UN/SCETDG/50/INF.7/Add.2 UN/SCEGHS/32/INF.5/Add.2

**Issues relating to the Globally Harmonized System
of Classification and Labelling of Chemicals: Use
of the Manual of Tests and Criteria in the context
of the GHS**

Revision of the Manual of Tests and Criteria: Part I: Section 18

**Transmitted by the Chairman of the Working Group on Explosives on
behalf of the Working Group**

Figure 18.7.1.1: VENTED PIPE TEST

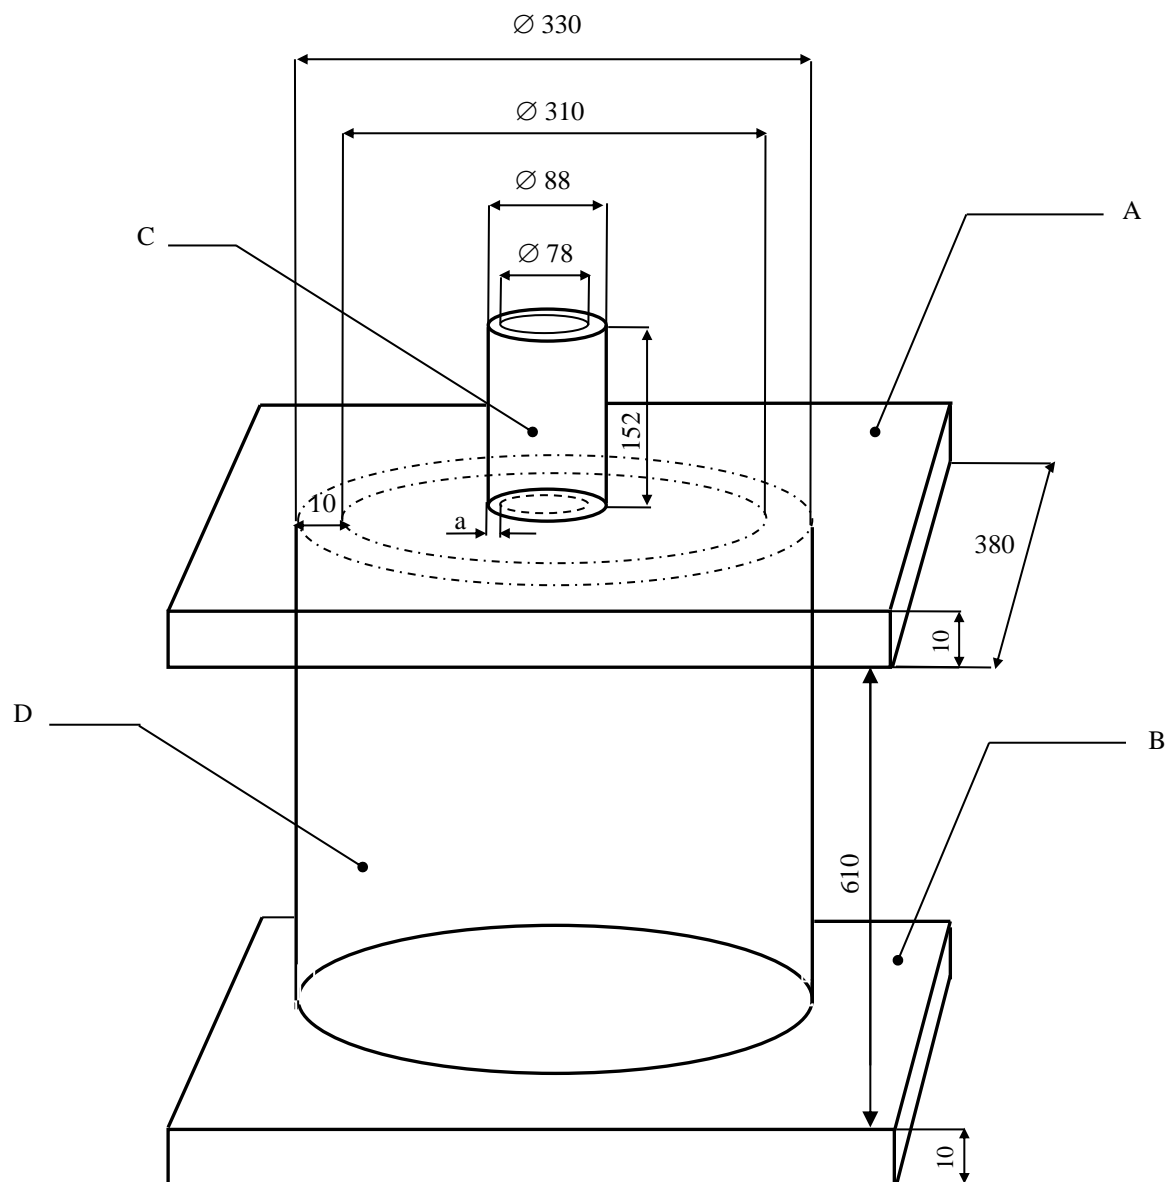
This test is not intended for classification but is included in this Manual for evaluating the suitability for [containment in tanks as an oxidizing substance, transport in tanks](#).

The test result is considered “+” and the substance should not be ~~contained + transported~~ in portable tanks as ~~a dangerous good of Division 5.1~~ an oxidizing substance if an explosion and/or fragmentation of the pipe, as specified in Section 18.7.1.3.3 (e) and (f) is observed.
